MEMORANDUM

On behalf of AM/DRI Block 44, LLC, NV5 is pleased to submit this memorandum providing response to comments and revised vapor intrusion mitigation system (VIMS) design drawings for the AM Blocks – Block 44 project southeast of the future intersection of South River Parkway and South Abernethy Street in Portland, Oregon.

AM BLOCKS - BLOCK 44

VAPOR INTRUSION/RADON MITIGATION SYSTEM

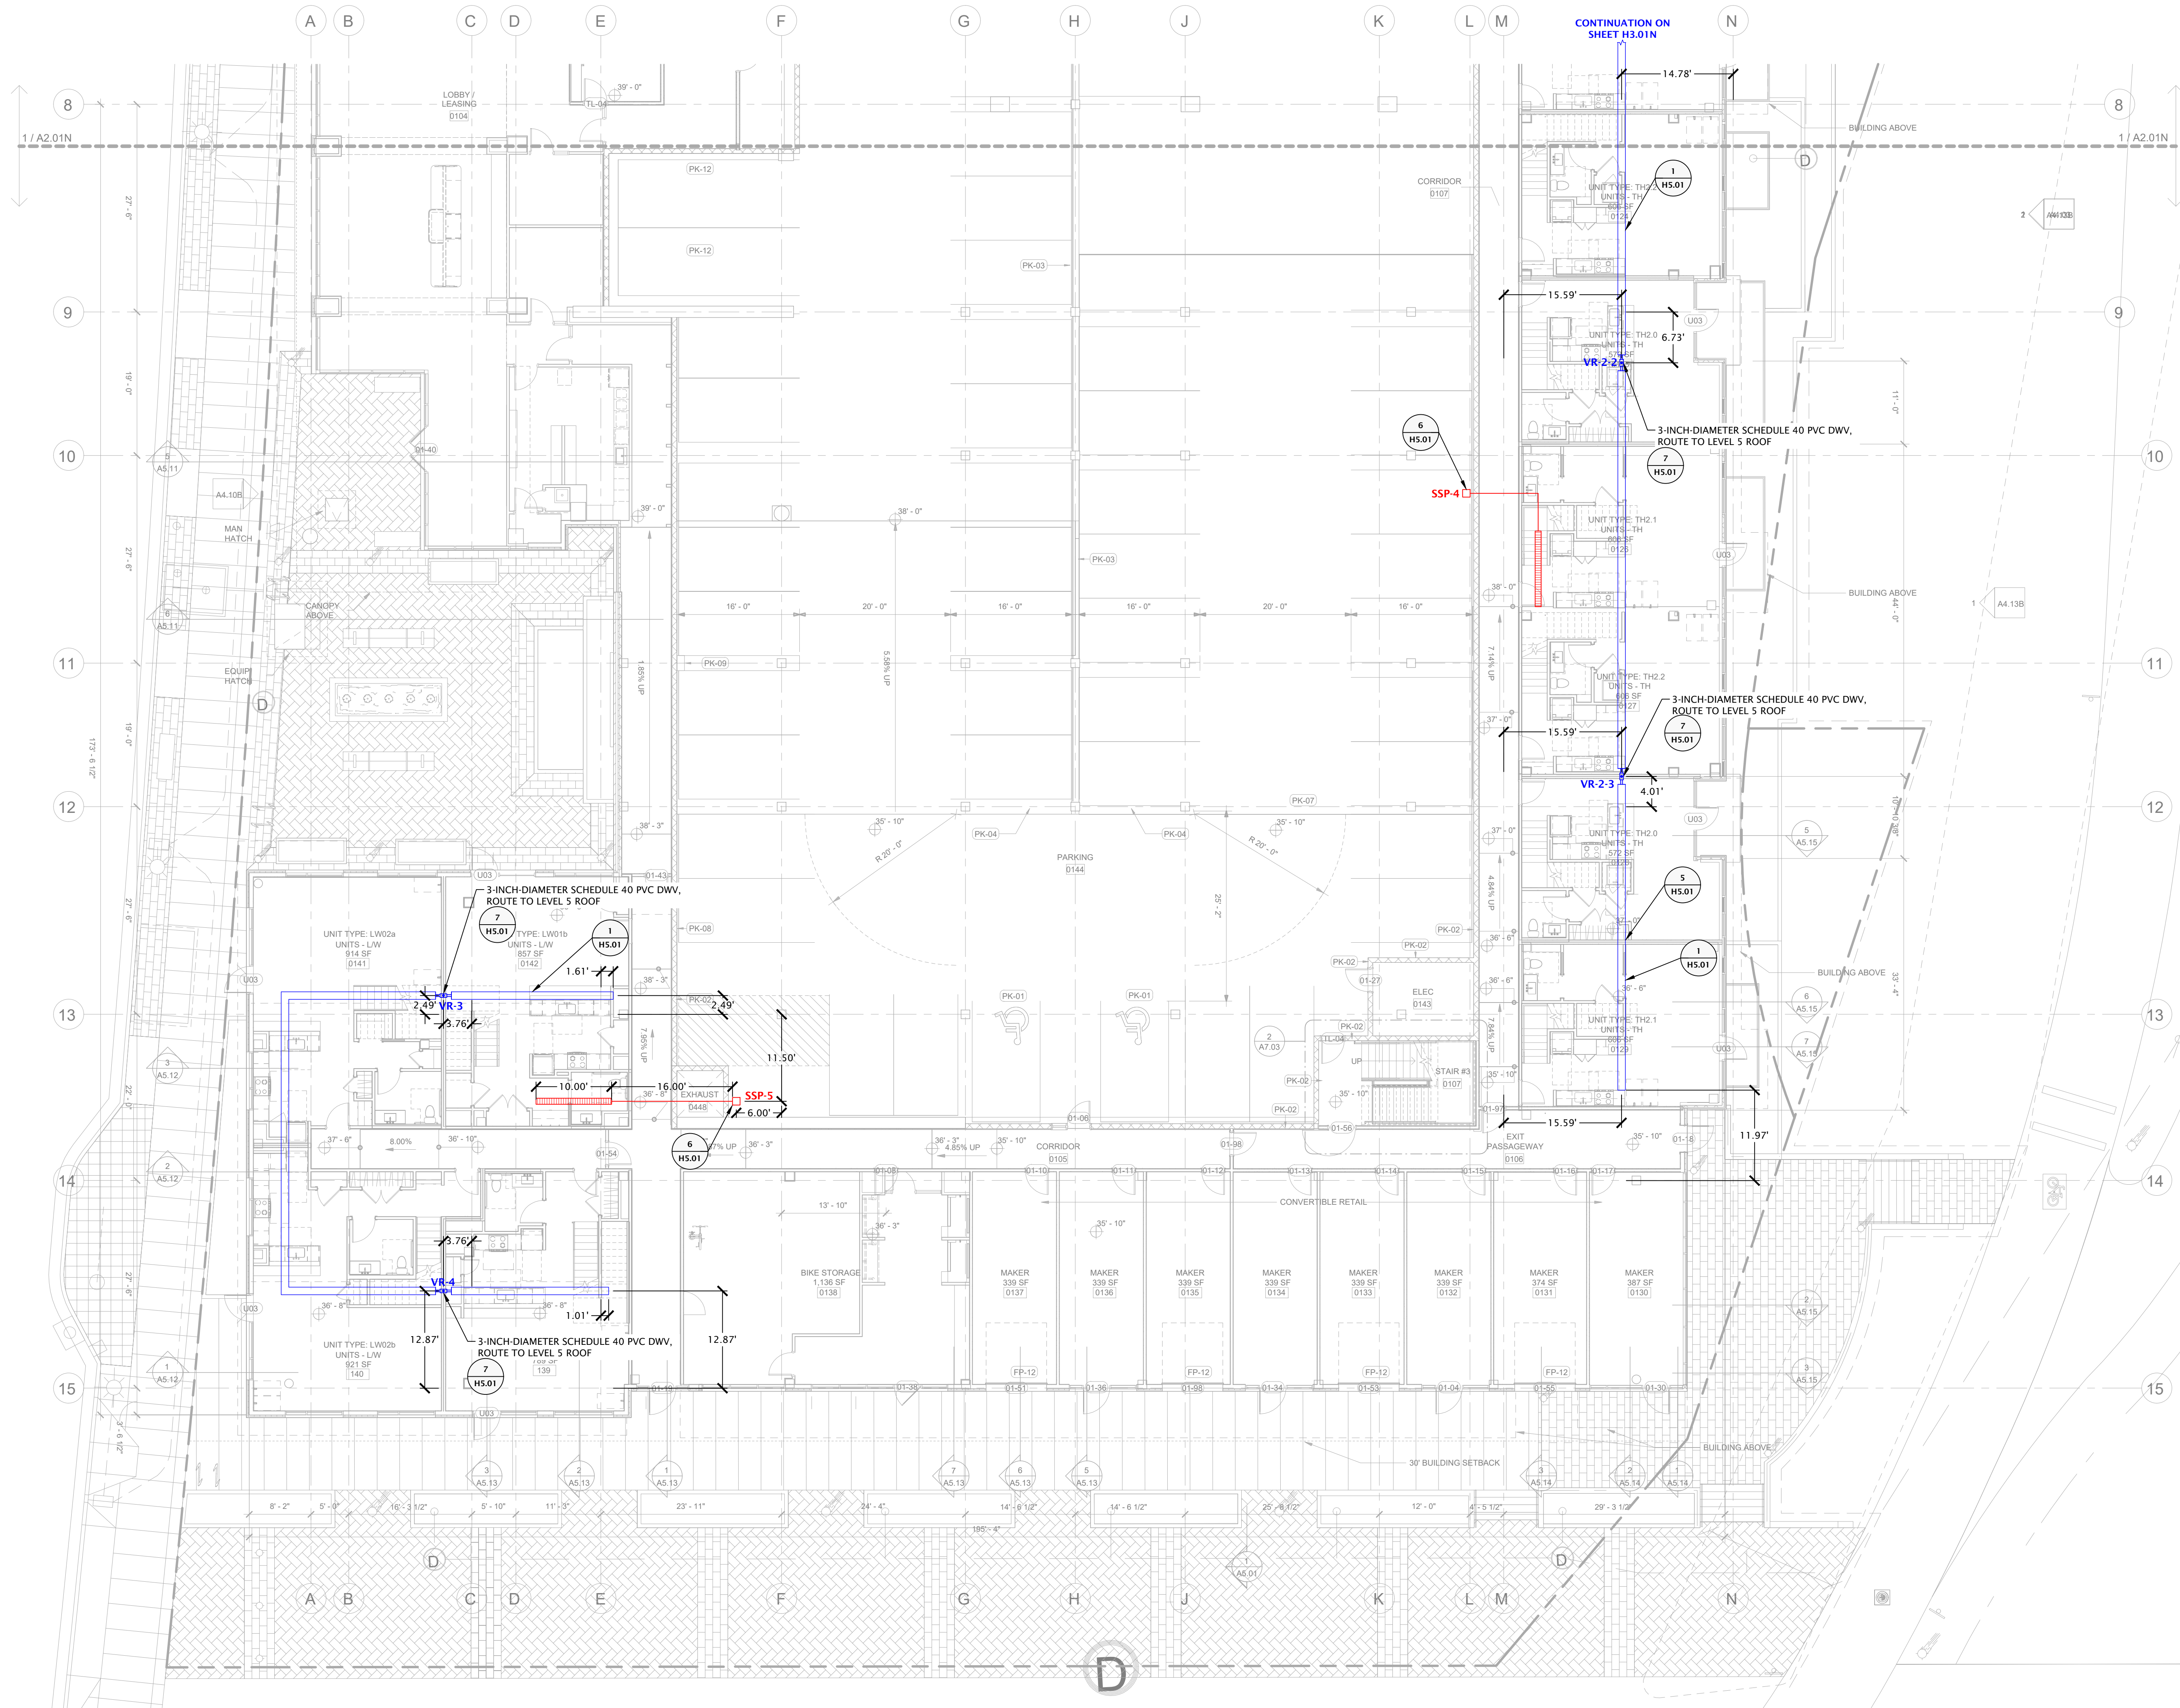
Sheet H3.01N/H3.01S - In general, the vent piping is currently just a linear pipe that is run through the center, and in some areas of the building and appears to achieve coverage below the entire slab

area for the residential units. What is the assumed distance of influence of the vent piping? Please verify that additional laterals are not necessary to achieve venting coverage across the entire area of the slab.

NV5 designed the sub-slab venting system based on the 2019 State of Oregon Structural Specialty Code (SOSSC) Section 1812, Radon Control Methods – Group R-2 and R-3 Occupancies, specifically Section 1812.2.5, Passive Subslab Depressurization System (Basement or Slab-On-Grade), and Section 1812.2.6, Subslab Soil Exhaust System Ducts (SSESD). Section 1812.2.5 requires sub-slab exhaust systems to comply with Section 1812.2.6. Section 1812.2.6 requires one SSESD (i.e., vent riser) for every 2,000 square feet of building sub-slab area. The number of vent risers meets this requirement. Calculations are shown on Sheets H3.01N and H3.01S. SOSSC 1812 does not require sub-slab vent piping.

However, the VIMS design includes sub-slab vent piping connected to the vent risers that allows increased sub-slab coverage for the vent risers and redundancy in the design. Additionally, NV5 based our VIMS design using the requirements in the Los Angeles Department of Building and Safety (LADBS) Methane Hazard Mitigation Standard Plan. We recognize these requirements may not be applicable in Oregon. However, they provide a sufficient basis for design and have been used to design several methane mitigation systems in Oregon under DEQ oversight.

Methane hazards are significantly greater than vapor intrusion hazards posed by volatile organic compounds (VOCs). Considering these risks, it is our opinion that the conservative nature of the LADBS methane standards is protective when used for VIMS designs. According to the LADBS methane standards, sub-slab vent pipe spacing for a 3-inch-diameter vent riser can be up to 75 feet. As discussed with DEQ, the VIMS is only needed under the residential units of the building. The widths of the residential units range between approximately 28 to 35 feet. Based on this, the single sub-slab vent pipe provides more than sufficient coverage under the LADBS methane standard. Considering the VIMS design meets the requirements of SOSSC 1812 and LADBS methane standards, the vent spacing as designed is sufficient and additional laterals are not warranted.

1 TYPICAL LOW-PERMEABLE MEMBRANE AND VENT PIPE DETAIL
H5.01 NOT TO SCALE

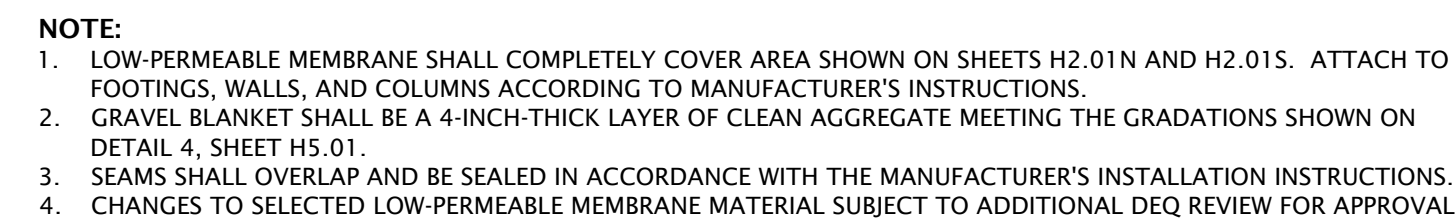
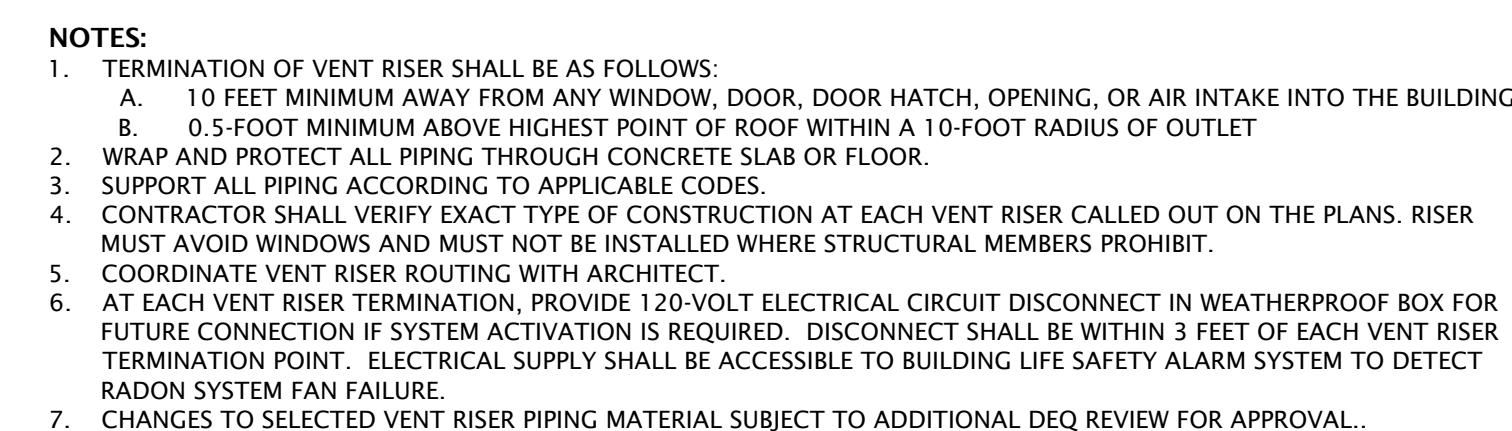
Sheet H5.01 –

1. Please add a note to this sheet that indicates any changes to membrane liner/vent piping are subject to DEQ review for approval.
2. Detail 6. The termination for the vent riser needs to include a vented cover to prevent rainfall from entering these lines.

1. A note was added to Detail 1, Sheet H5.01.
2. Detail 6 was modified to show a “candy cane” termination configuration to help prevent rainfall from entering the lines.
